Issue Date: 01 July 1988 RAC No. 315 Rev. B

SUBJECT: PHANTOM RESERVE KEVLAR REINFORCING BANDS

MANUFACTURERS SERVICE BULLETIN:

FIGURE 1 - PHANTOM CANOPY SECTION

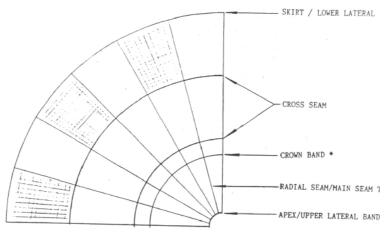
Areas: Upper lateral band and crown band. See figure 1.

Figure 3

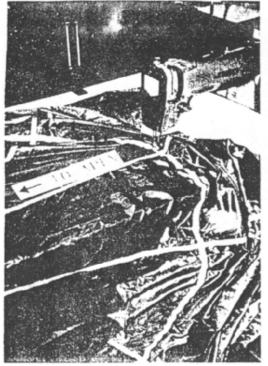
Find original band overlap, locate opposite side of canopy to start. Position canopy in machine with apex to left (figure 3). Place second layer of kevlar tape over existing kevlar crown band (nylon in earlier canopies).

Figure 5

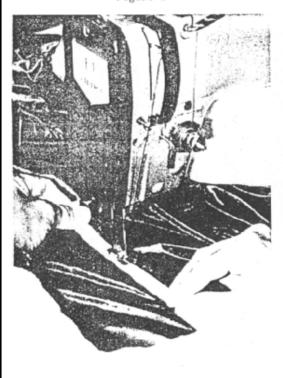
Begin sewing 1" before radial seam tape (figure 4). Keep kevlar tape under moderate tension (2-3 pounds) (figure 5). Continue sewing around entire crown band duplicating original stitching. To finish, overlap the kevlar one full panel plus 2" and cut tape (figure 6). Fold end under 1" to butt against radial seam tape. Continue stitching 2: past folded end of tape.
